**TOWN OF NEWBURGH  
PLANNING BOARD  
TECHNICAL REVIEW COMMENTS**

**PROJECT NAME:** TARBEN II SUBDIVISION  
**PROJECT NO.:** 21-18  
**PROJECT LOCATION:** SECTION 127, BLOCK 1, LOT 12  
**REVIEW DATE:** 15 SEPTEMBER 2023  
**MEETING DATE:** 21 SEPTEMBER 2023  
**PROJECT REPRESENTATIVE:** ZEN CONSULTANTS

Tarben II Subdivision - Lot #12  
SBL: 127-1-12

**LANDS OF TARBEN INC.**  
 LOT 12 - 2 LOT SUBDIVISION  
**LAYOUT PLAN**  
 SBL: 127-1-12  
 TOWN OF NEWBURGH, ORANGE CNTY.

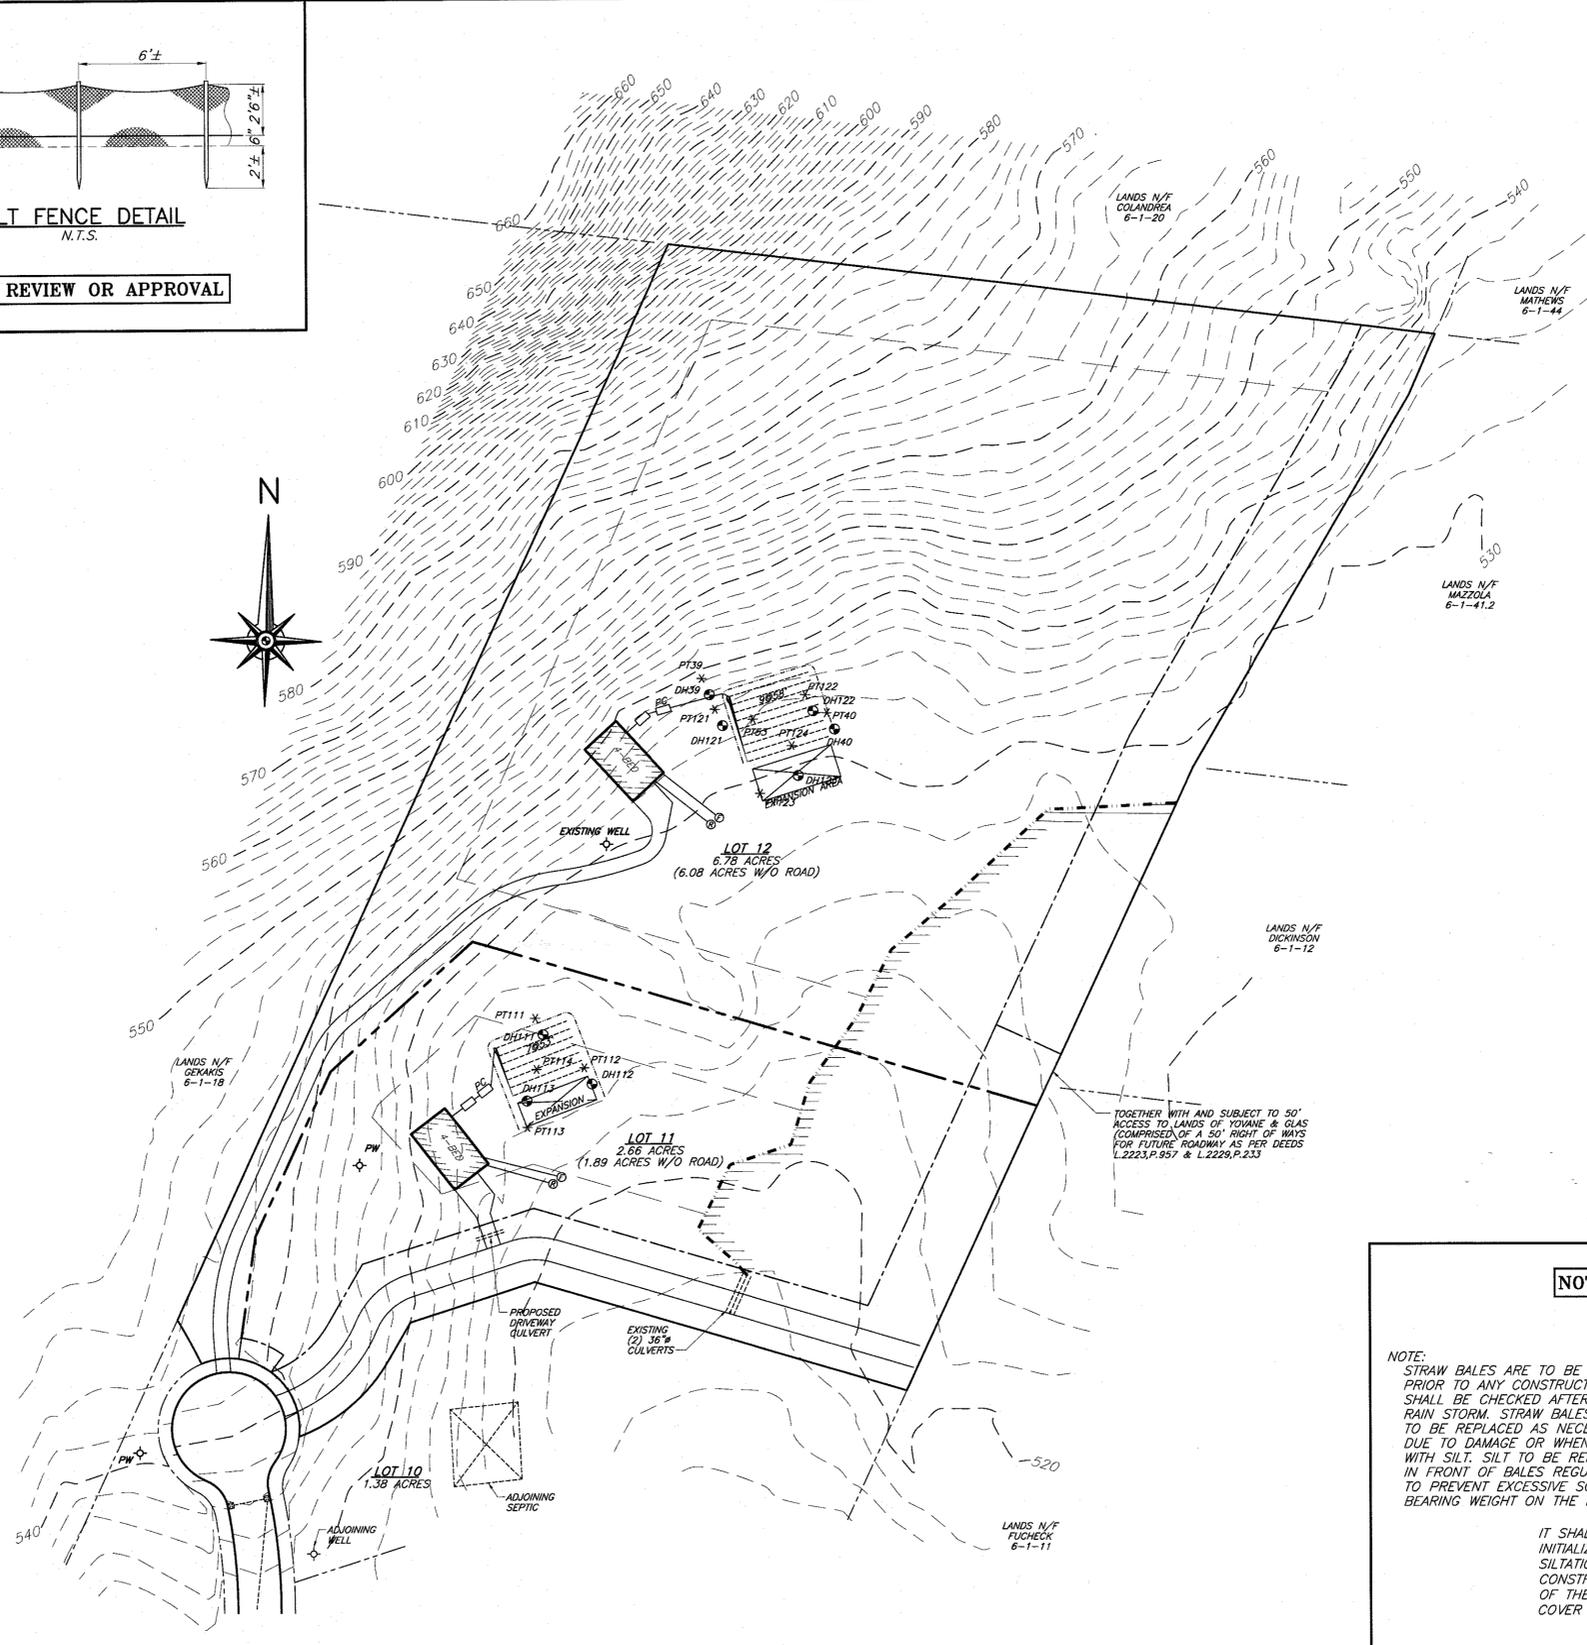
3. *The subsurface sanitary sewer disposal system and well on lot #10 should be depicted* - This information has been added to the plans.
4. *Plans should show a building envelope based on the underlying zoning and restrictions based on the easement identified to provide a future Town roadway. The lot size should be calculated with the future Town roadway easement removed and any setbacks should be taken from the right-of-way line.* - The building envelope has been adjusted and the lot size re-calculated.

5. *Front yard would be measured for the flag lot where the lot has minimum lot width. Lot size calculation should be provided with and without the easement area.* - Front yard setback has been adjusted and the lot size re-calculated.

6. *Provisions for drainage at the Town roadway/driveway connection should be evaluated* - A driveway culvert has been added to the plan.
